Stone replacement on north side of chimney CS18

Revision: 01
See note in revision cloud
Date: 21 June 2024

OTH-PUR-TH-RF-SKE-A-3669

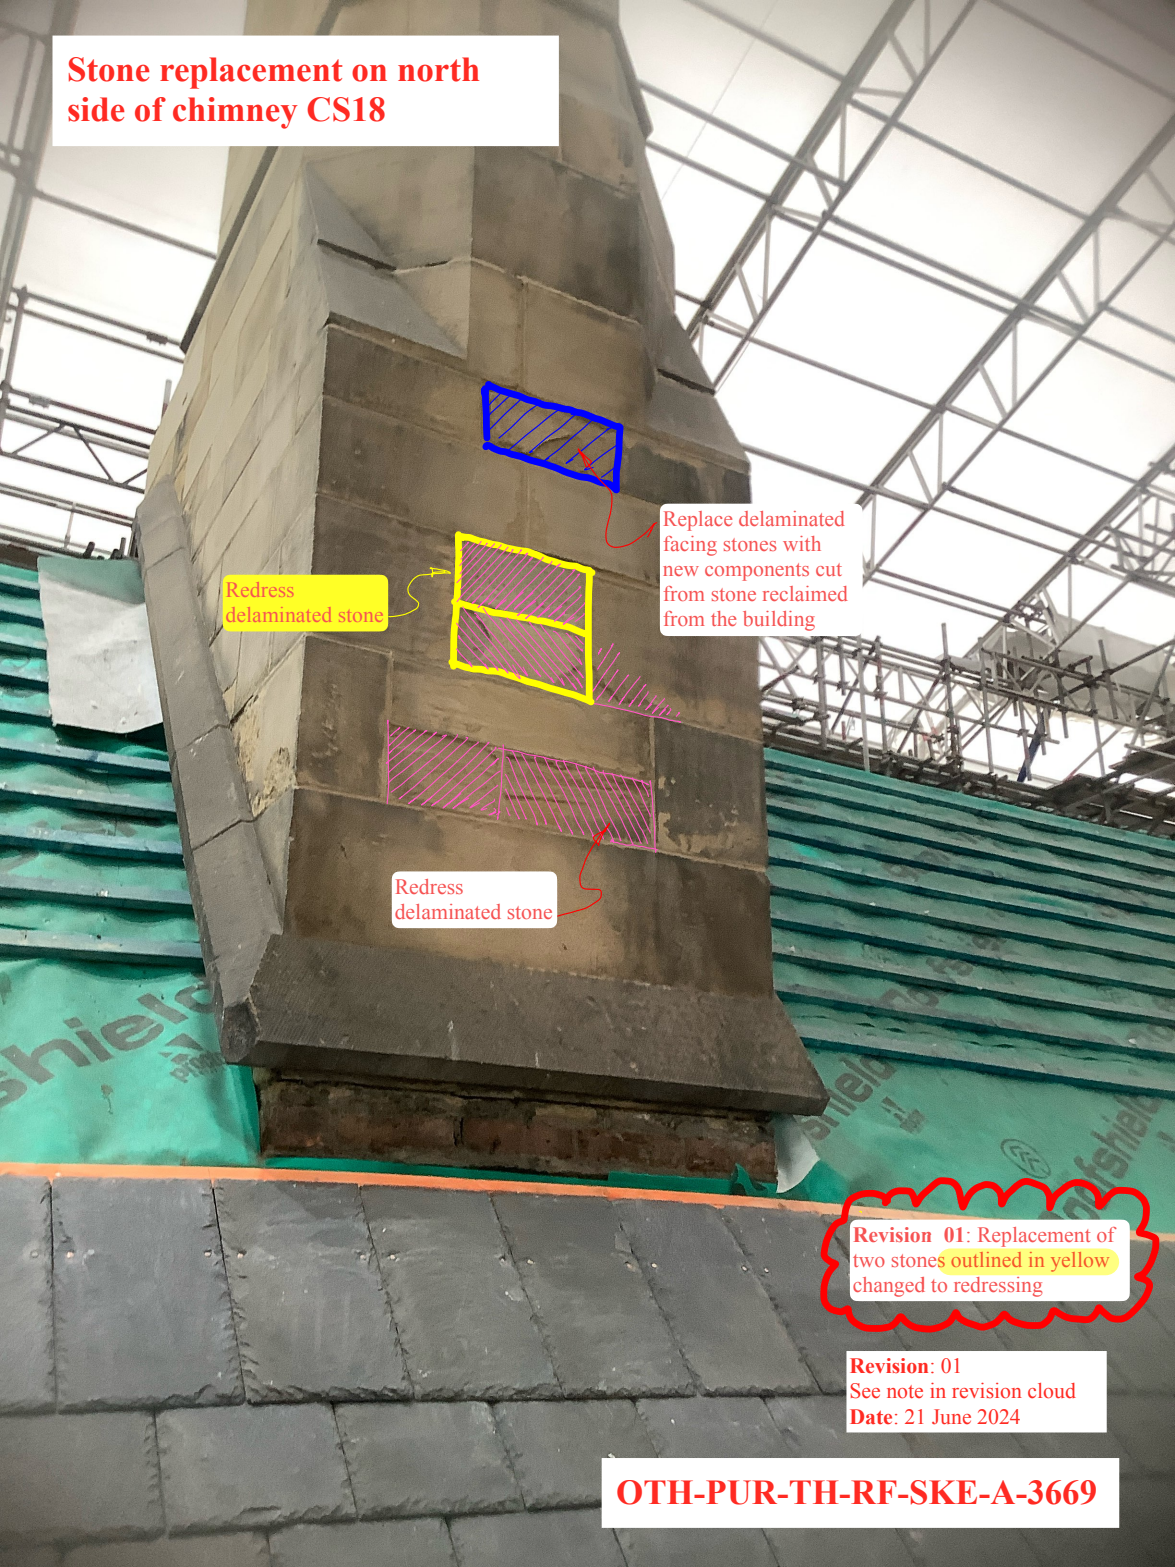
Redress
delaminated stone

Replace delaminated
facing stones with
new components cut
from stone reclaimed
from the building

Redress
delaminated stone

Revision 01: Replacement of
two stones outlined in yellow
changed to redressing
